COMMISSION OF ARCHITECTURAL REVIEW REGULAR MEETING AGENDA

July 25, 2024

DATE: July 25, 2024
TO: Commission of Architectural Review
FROM: Renee Burton, Division Director of Planning
RE: Certificate of Appropriateness application PZ24-00322 filed by Maurie Van Buren for fence in the front and side yard at 125 Chestnut Street (Parcel 23257).

DATE: July 25, 2024
TO: Commission of Architectural Review
FROM: Renee Burton, Division Director of Planning
RE: Certificate of Appropriateness application PZ24-00305 filed by Steven Korzekwa to renovate enclosed rear porch at 162 Sutherlin Avenue (Parcel 25675).

① Photo of picket fence at 125 Chestnut St.

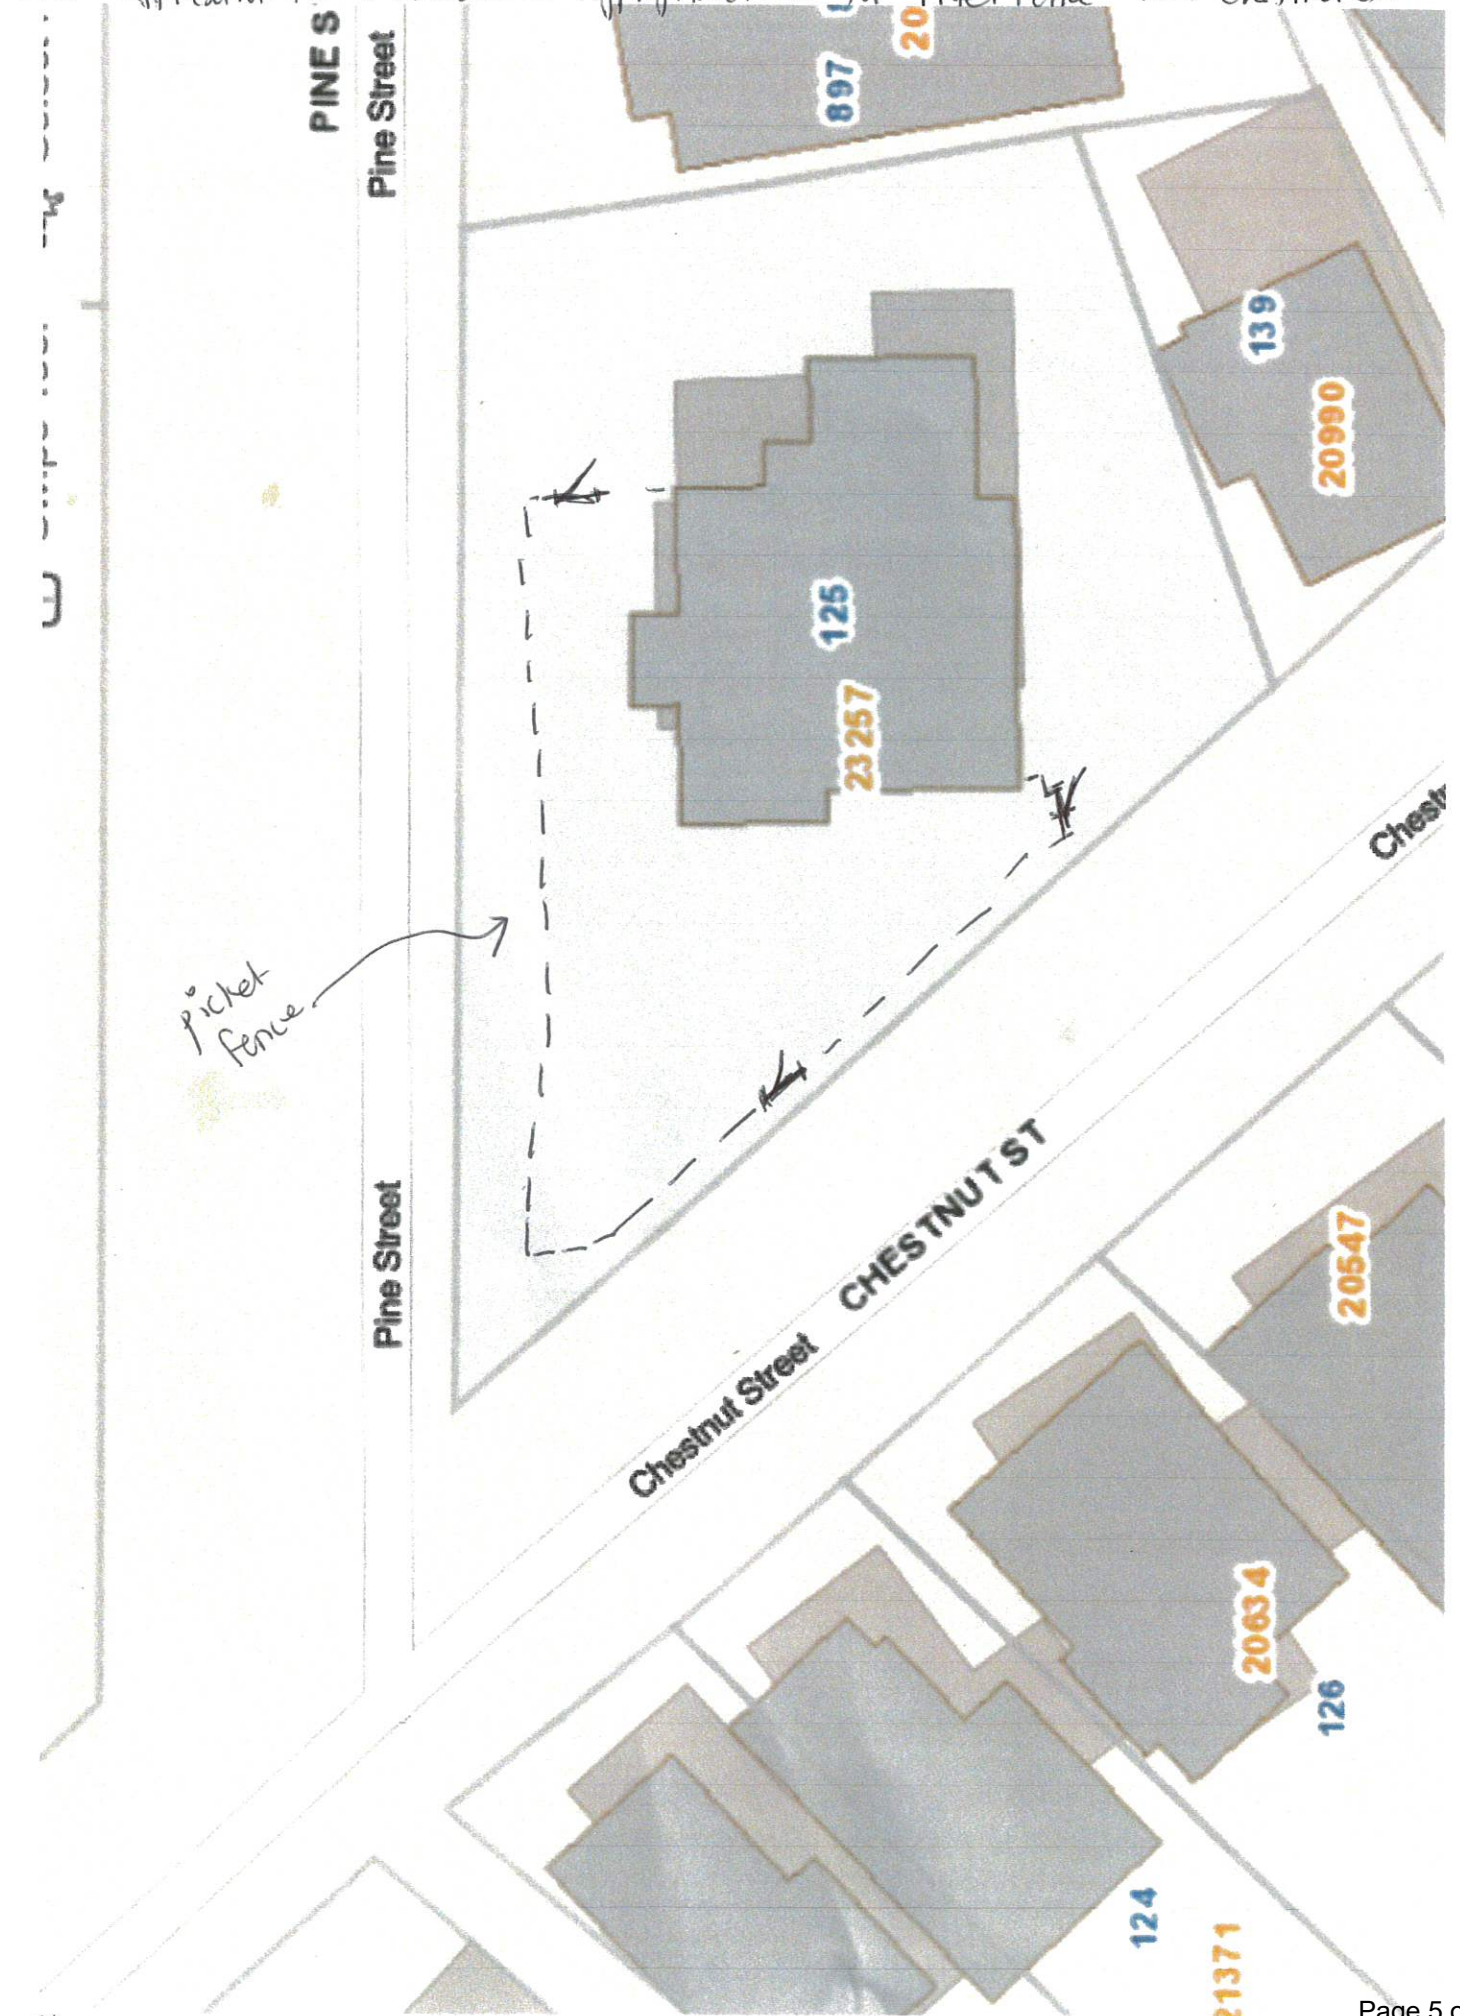
The applicant is requesting a Certificate of Appropriateness for an existing fence at 125 Chestnut Street. The fence was constructed without a Certificate of Appropriateness. In June, a zoning violation letter was sent to the property owner at 125 Chestnut Street, Maurie Van Buren. Ms. Van Buren then submitted an application for approval.

The fence, which encloses the front yards along Chestnut and Pine Streets, is a wood picket fence that is less than four (4) feet in height.

The Planning Division staff recommend approval of Certificate of Appropriateness application PZ24-00322 for a fence in the front yard at 125 Chestnut Street (Parcel 23257). The fence meets the regulations of the Zoning Code and OWE Design Guidelines.

Past, Current and Proposed Footprint

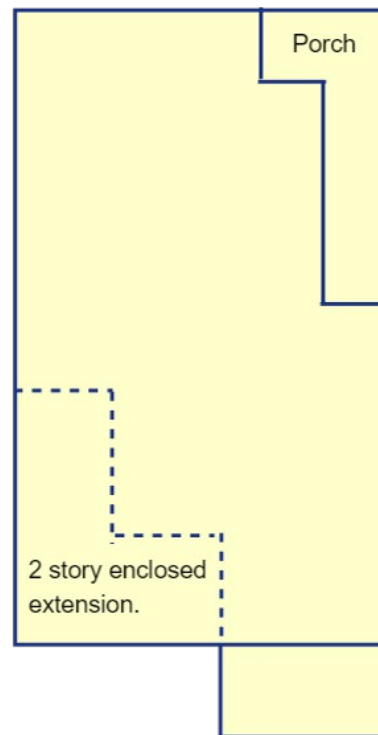
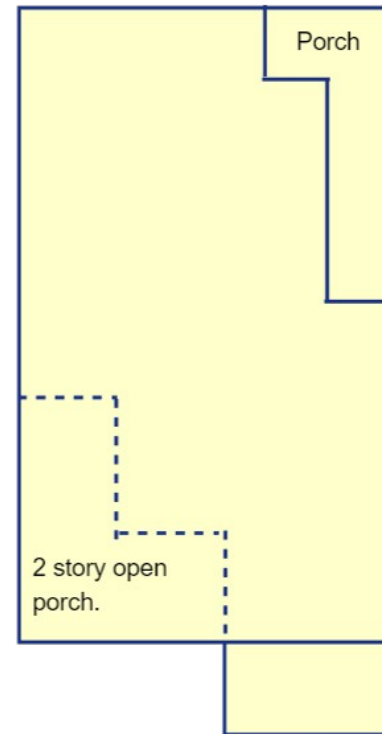
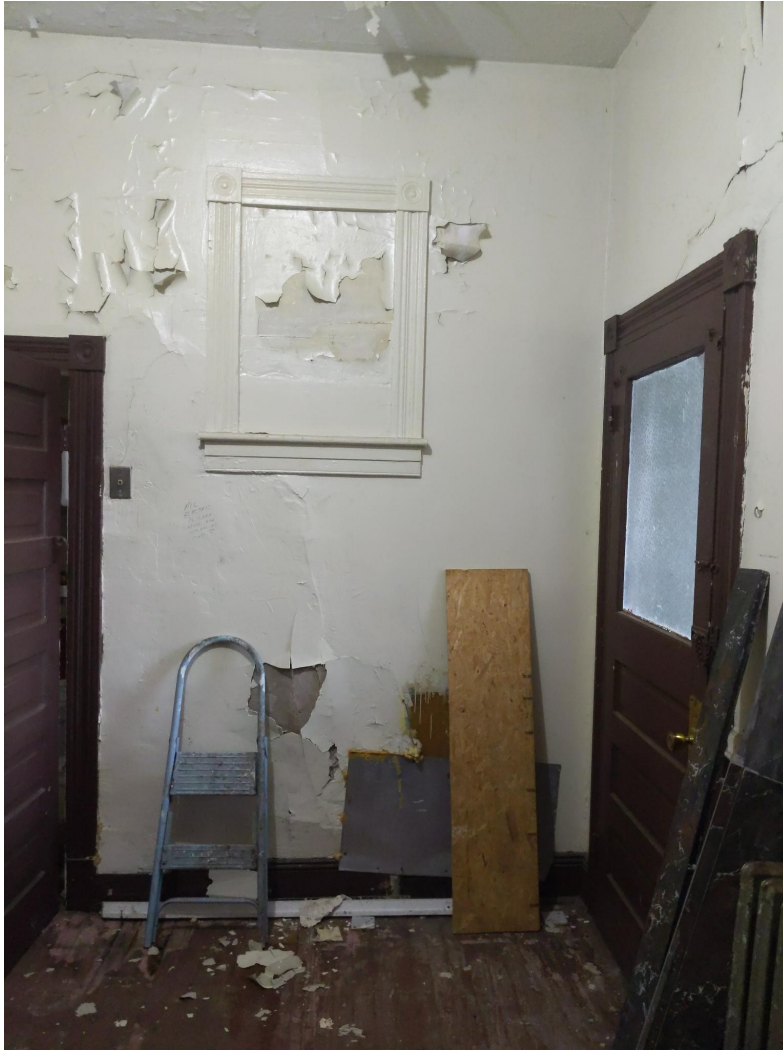
The applicant is requesting a Certificate of Appropriateness to renovate the existing enclosed porch to convert it into an open porch. The enclosed porch is in disrepair and is not original to the house. The proposed updates will not change the footprint of the structure.

The applicant proposes to remove the outer walls of the porch, retaining the existing doors and windows on the original exterior wall. Any necessary replacements will match the current design. The newly exposed walls will be sided to match the rest of the exterior walls. The columns and railings will match those on the front porch.

The Planning Division staff recommend approval of Certificate of Appropriateness application PZ24-00305 to renovate enclosed rear porch at 162 Sutherlin Avenue (Parcel 25675). The proposed construction meets the OWE Design Guidelines.
